Access Compliance Report

Public Rights-of-Way

(Curb Ramps)

Intersection ID: 54155	Main Street: SANDERS_FARM_LN	Cross Street: DEWEY_CREEK_LN	Location: NW
ADA ID: 463D6388C9CB	Ramp Type: Perp	Initial Pass/Fail: Fail	Overall Compliance: No
Severity Score: 13.75			
Codes/Mitigation Info/Possible Solution		Field Measurements/Component Compliance

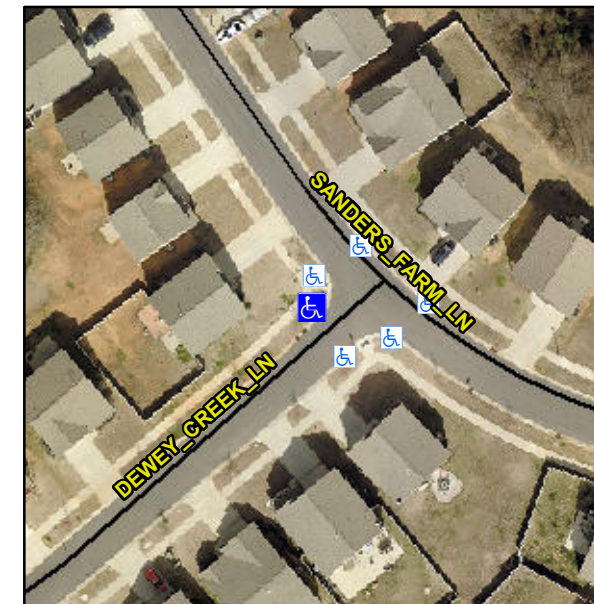
R304.2.2, R304.5.3

Compliance	Description	Data	Compliance	Description	Data
N/A	Ramp Length (in)	95.5	No	Ramp Slope (%)	11.3
Yes	Ramp Width (in)	60.0	No	Ramp XSlope (%)	2.6
N/A	Flare Type LT	N/A	N/A	Flare Type RT	N/A
N/A	Flare Slope LT (%)	N/A	N/A	Flare Slope RT (%)	N/A
N/A	Flare Traversable LT?	N/A	N/A	Flare Traversable RT?	N/A
N/A	Landing Length (in)	N/A	N/A	DWS Provided?	N/A
N/A	Landing Width (in)	N/A	N/A	DWS Contrast?	N/A
N/A	Landing Slope (%)	N/A	N/A	DWS Length (in)	N/A
N/A	Landing X Slope (%)	N/A	N/A	DWS Full Width?	N/A
N/A	Landing Curb? (Y/N)	N/A	N/A	DWS Offset (in)	N/A
N/A	Shared Landing?	N/A			
N/A	Gutter Ponding?	N/A	N/A	Gutter Slope (%)	N/A
N/A	Gutter Lip Ht (in)	1.5	N/A	Gutter X Slope (%)	N/A
N/A	Painted X Walk1?	No	N/A	Painted X Walk2?	N/A
	X Walk 1 Direction	To S		X Walk 2 Direction	N/A
N/A	X Walk 1 Width (in)	N/A	N/A	X Walk 2 Width (in)	N/A
	X Walk 1 Slope (%)	0.9		X Walk 2 Slope (%)	N/A
	X Walk 1 X Slope (%)	0.6		X Walk 2 X Slope (%)	N/A

Remove & Replace Entire Ramp.
